Memorandum

Subject: **SITE PLAN REVIEW**—1900 N Croatan Highway in the Commercial Zone — Proposed Convenience Store and Gas Station

**RE: *2nd Site Plan Submittal for Wawa Croatan Highway
1900 North Croatan Highway
Kimley-Horn #116543032***

CANOPY SIDE ELEVATION

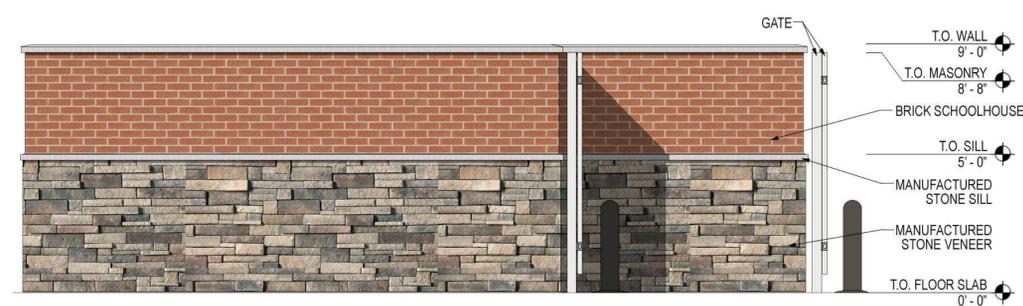
- a. Canopy lighting shall be shielded and contained within the perimeter of the canopy as to not have glare onto US158, 4th Street, and adjacent properties.
- b. Revised average minimum/maximum on proposed canopy lighting to match footcandles produced.

LEFT ELEVATION, 4TH STREET

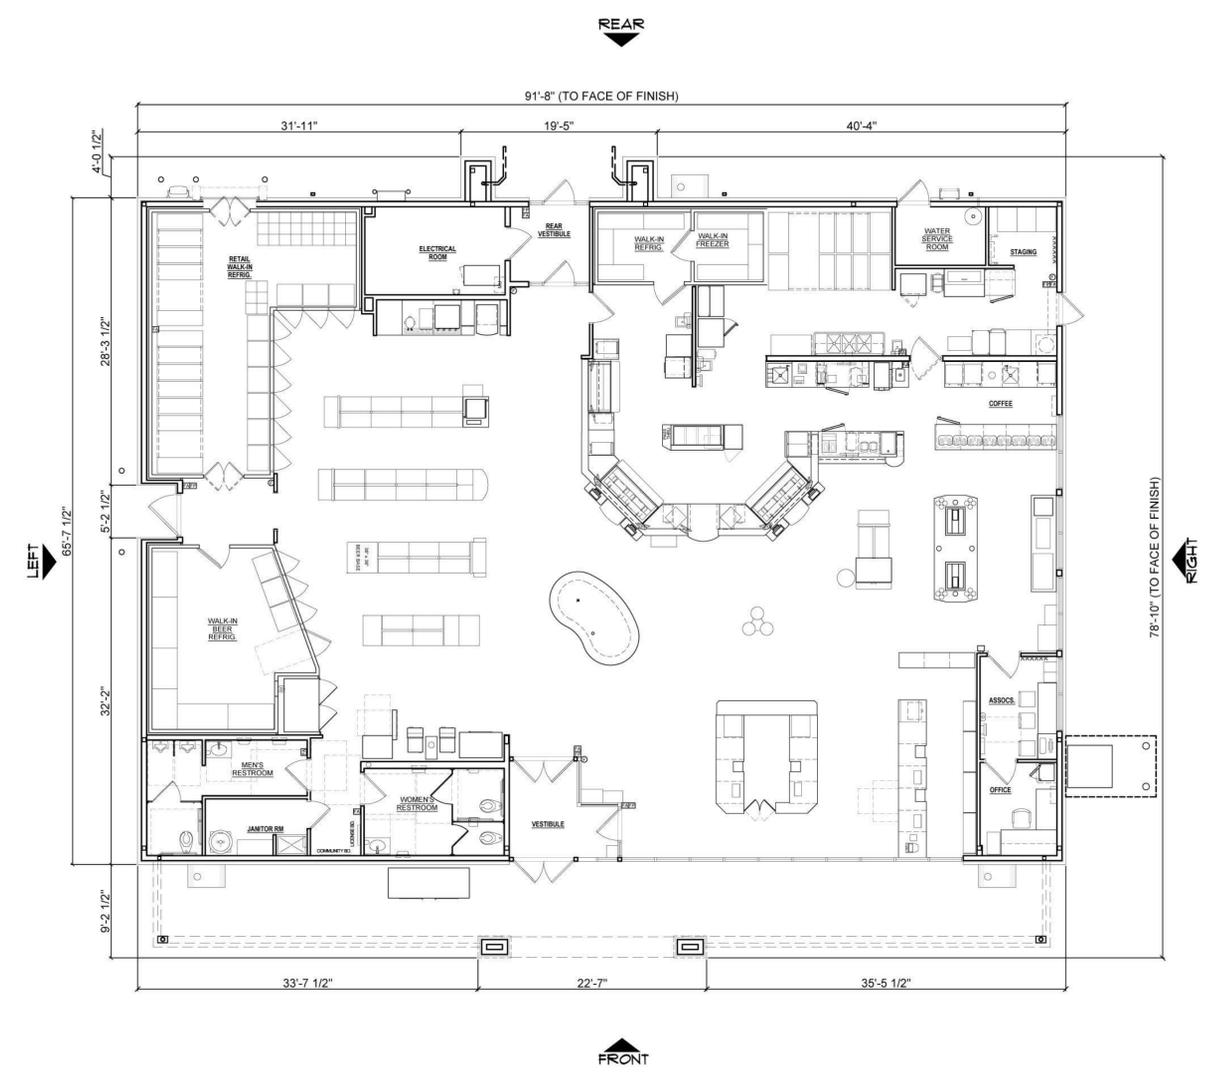
- a. Note Roof Height from top plate to ridge.
- b. Note Roof Overhang.
- c. Note Roof Slopes.
- d. Provide Glazing Calculations for US158 and 4th Street Elevations.

SHEET NUMBER
CE101

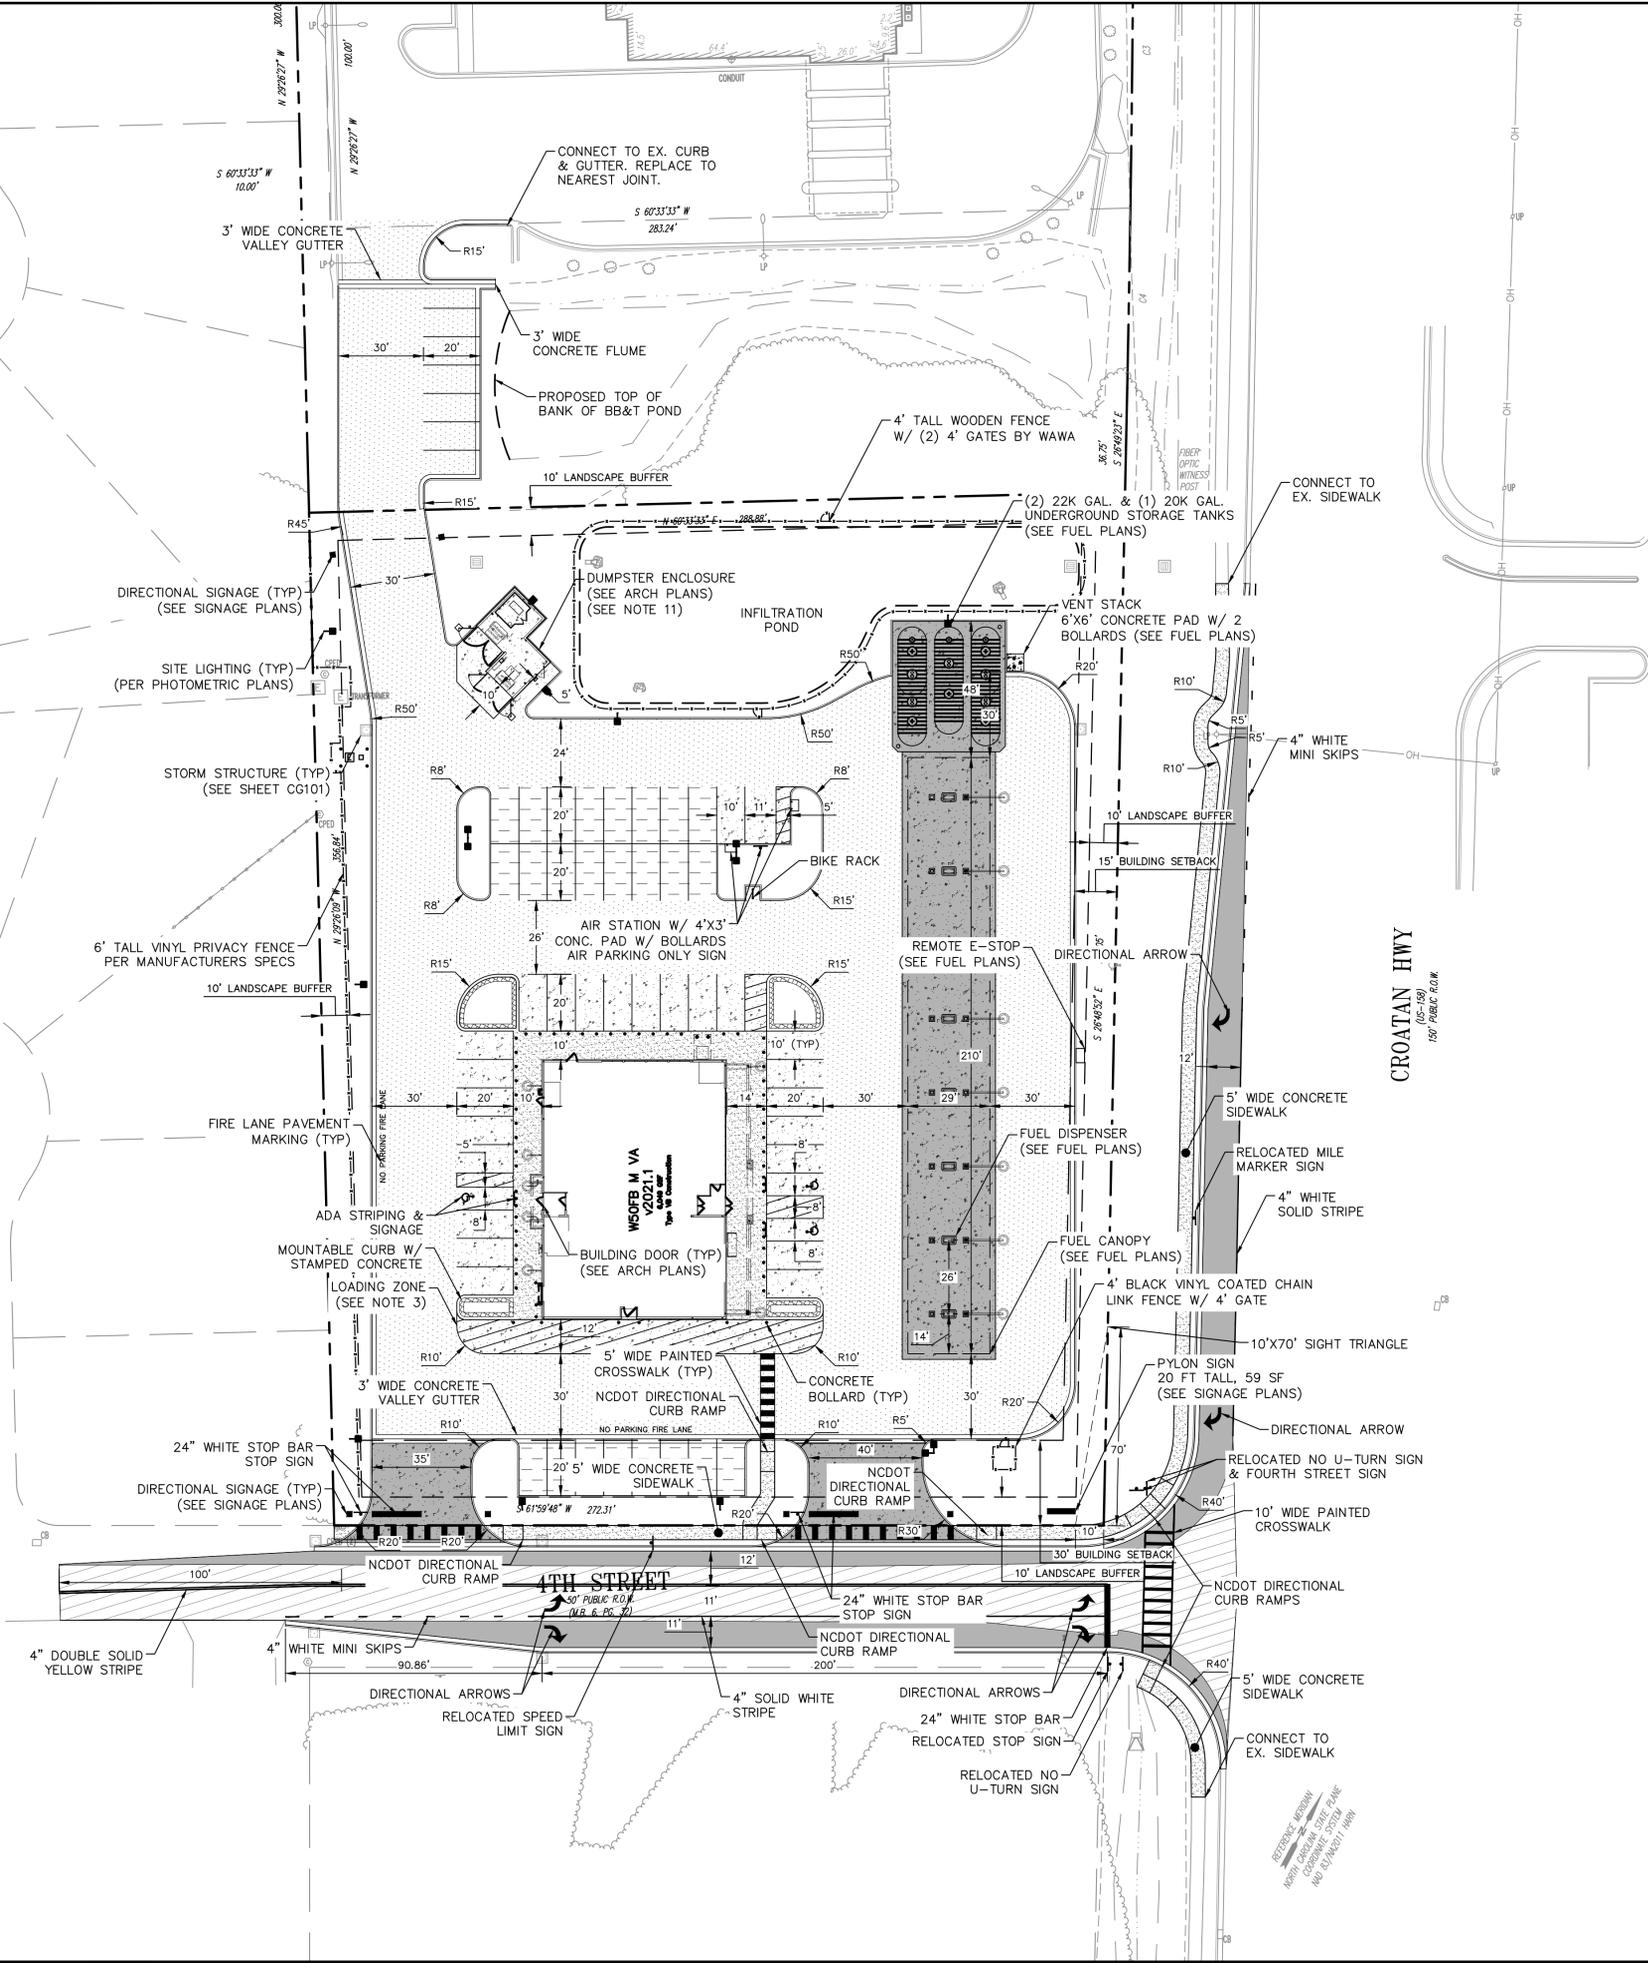
- a. (CE101):
 - i. Add note to proposed construction entrance and silt fence "Reference sheet CS503 for details".
 - Callouts were added to the erosion and sediment control plan (CE101).

- ii. Construction entrance shall be 20' wide and 50' deep.
 - The construction entrance dimensions were adjusted (CE101, CS503).
 - iii. Add note "Sidewalk along US-158 shall remain accessible as much as feasibly possible during construction."

- a. "CHILDREN AT PLAY" SIGN TO REMAIN: Change to. REMOVE "CHILDREN AT PLAY" SIGN
 - The sign is called out to be removed (CE101).
- b. Make sure E&S measures relating to work in roadside ditch in right of way of N Croatan Hwy and in West Fourth St are adjusted based on work scope changes resulting from these and other comments.
 - The erosion and sediment control measures were updated. Silt fence and culvert inlet protection are proposed (CE101).

SITE PLAN

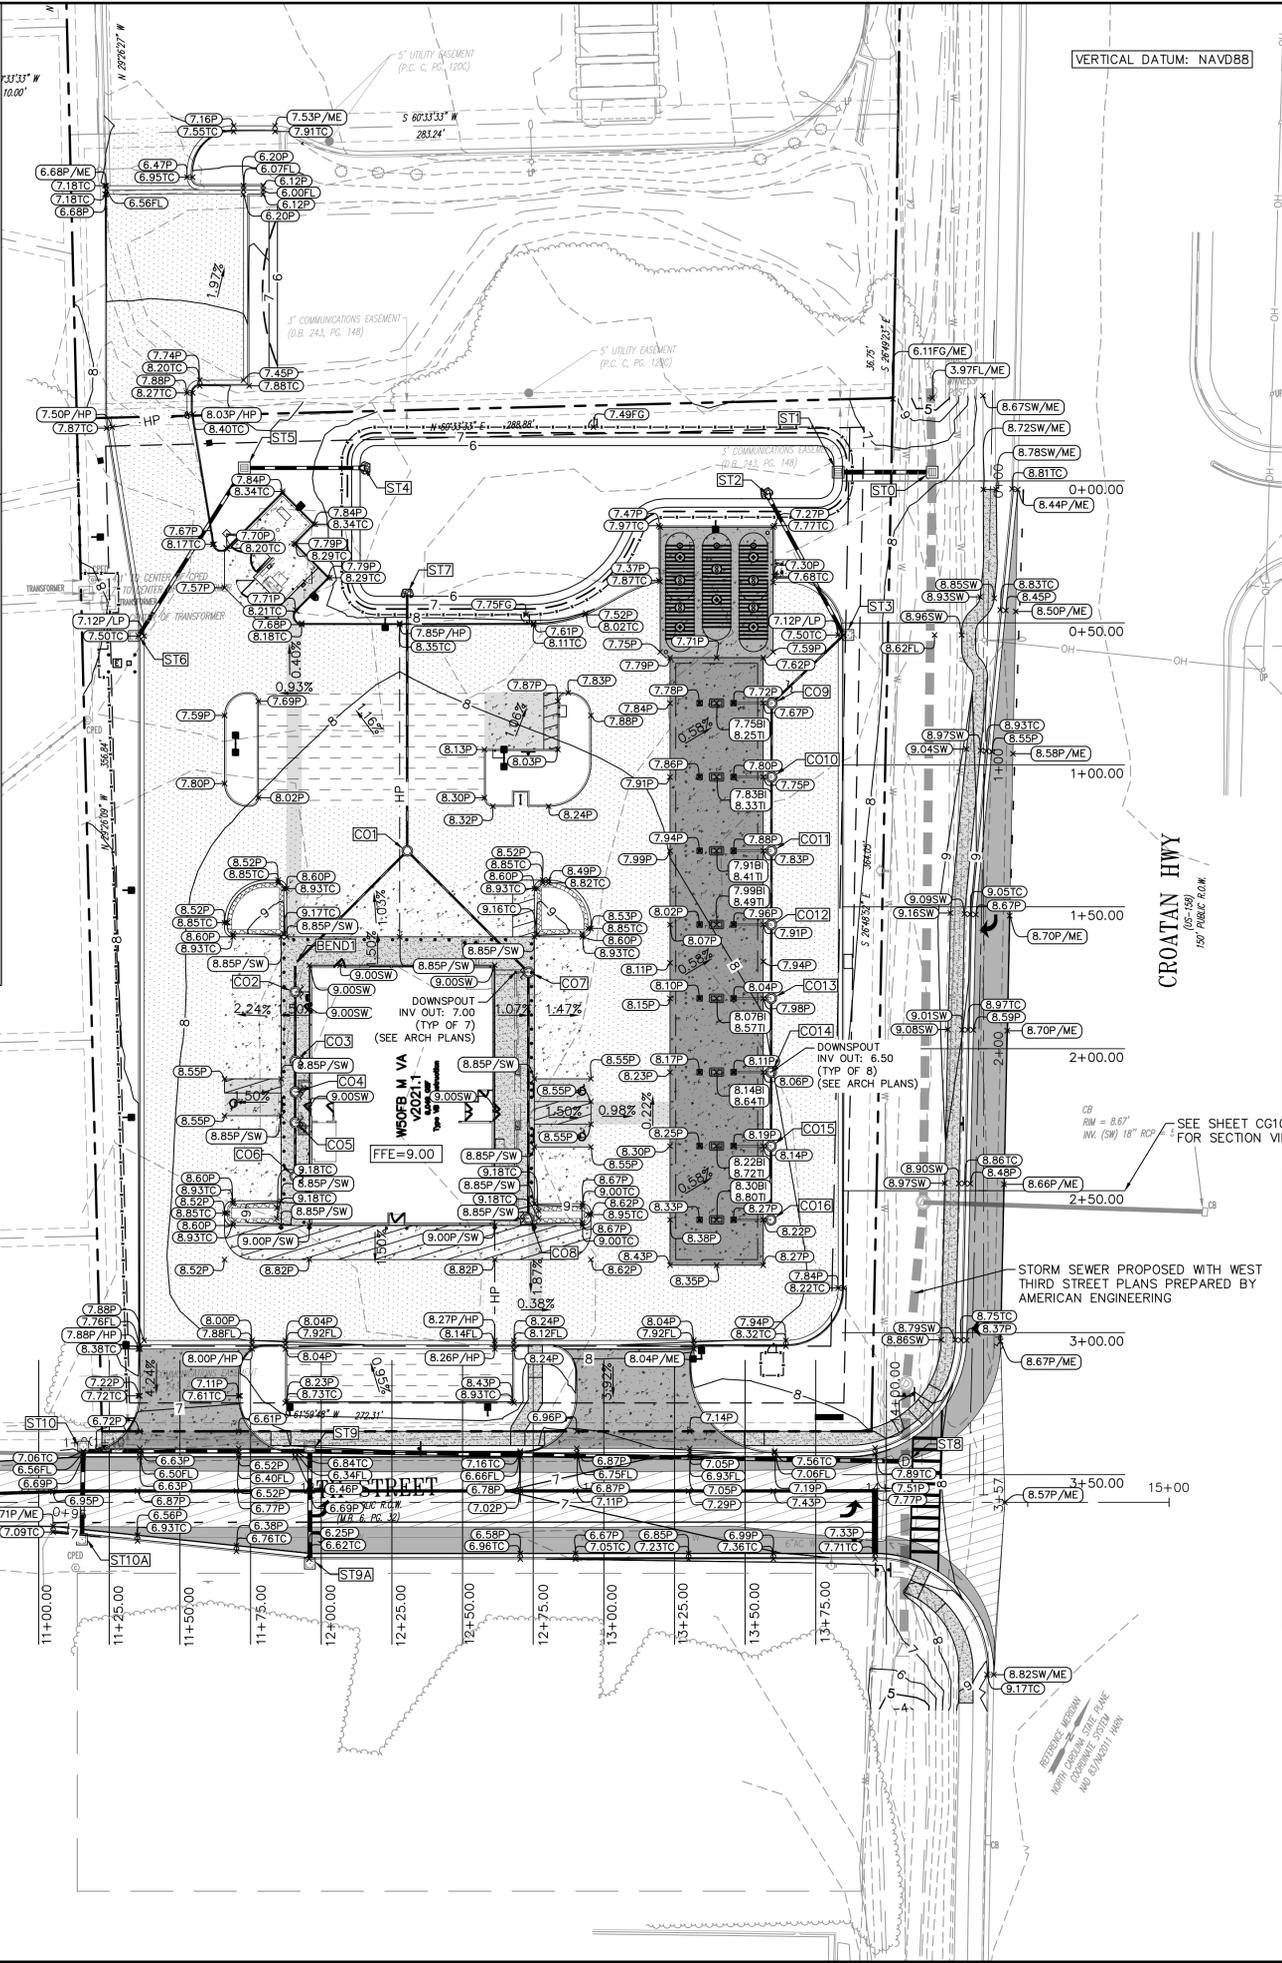
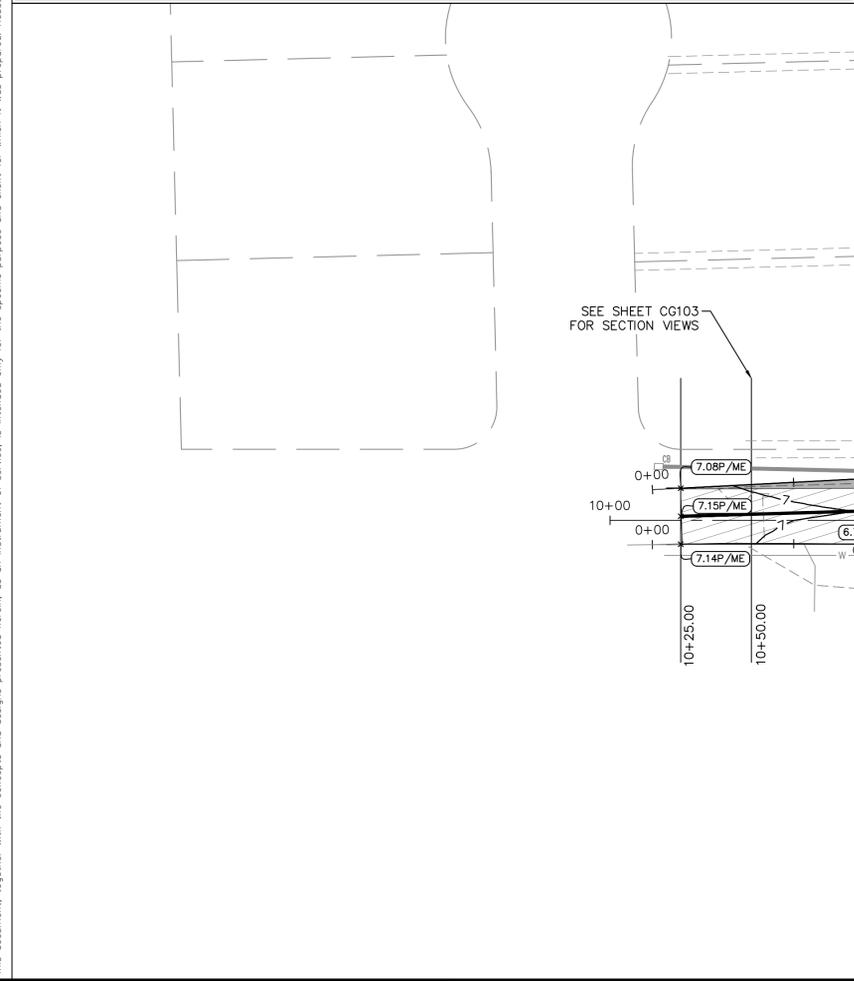
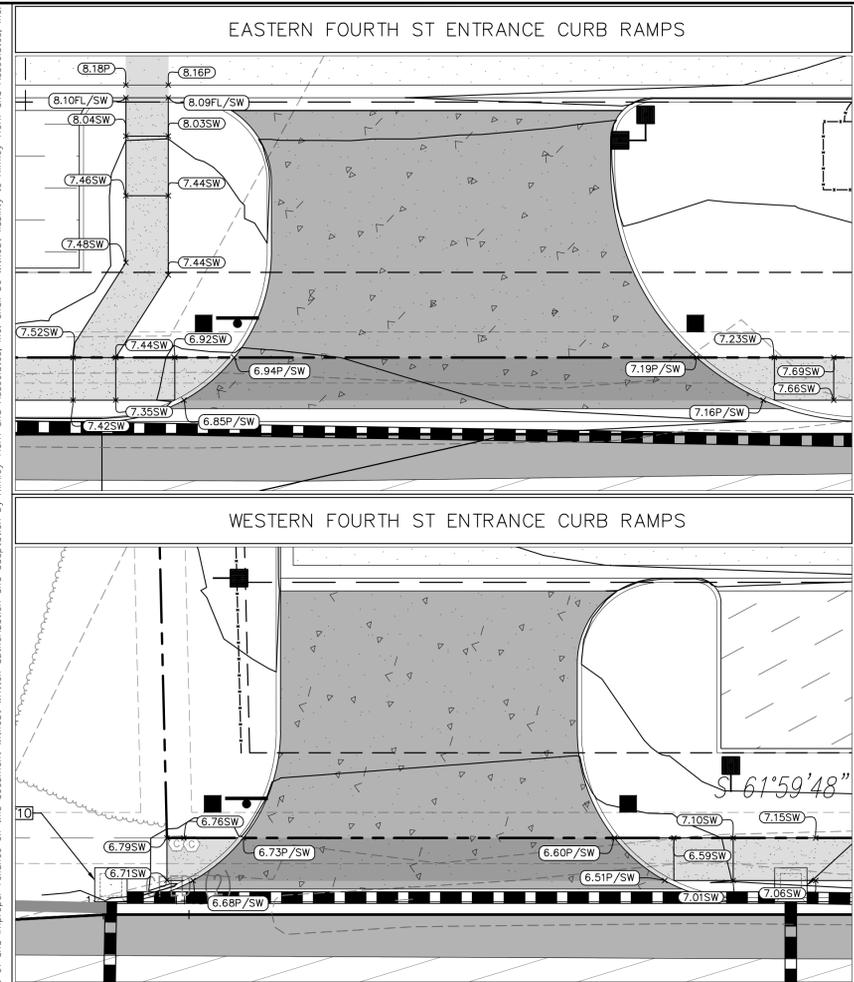
- a. Proposed landscaping fence on Western property line shall have the required landscaped area be located between the fence and the property line. Fence is shown on North West corner along property line. Fence and landscaping buffer shall be extended across the property line adjacent to the proposed interconnected drive aisle and parking on the adjacent parcel.
- b. Connection Agreement between WAWA and Truist Bank required.
 - i. Administrative approval and permit required separately.
 - ii. Provide written agreement of interconnection.

- The setbacks were revised throughout the plan set (CA001, CS101).
 - ii. Dimension drive aisle distance between curbs north of proposed dumpsters.
 - The drive aisle north of the dumpster enclosure is 30' wide. A dimension is provided on the site plan (CS101).

- iii. NC DOT Sight Triangle Dimensions (10'x70') are required for Sight Triangle at entrance of US158 and 4th Street.
 - A 10'x70' sight triangle is shown on the site plan (CS101).

- 4" solid yellow striping is provided in West Fourth Street. Note #5 was added to the site plan stating that all striping in the right-of-way must be thermoplastic in accordance with NCDOT standards (CS101).

- Note #10 was added to the site plan (CS101).
 - e. The sidewalk along US 158 should maintain a 5.0-foot buffer strip between the back of curb of the deceleration lane and the eastern edge of the sidewalk. This layout is consistent with portions of the existing sidewalk.
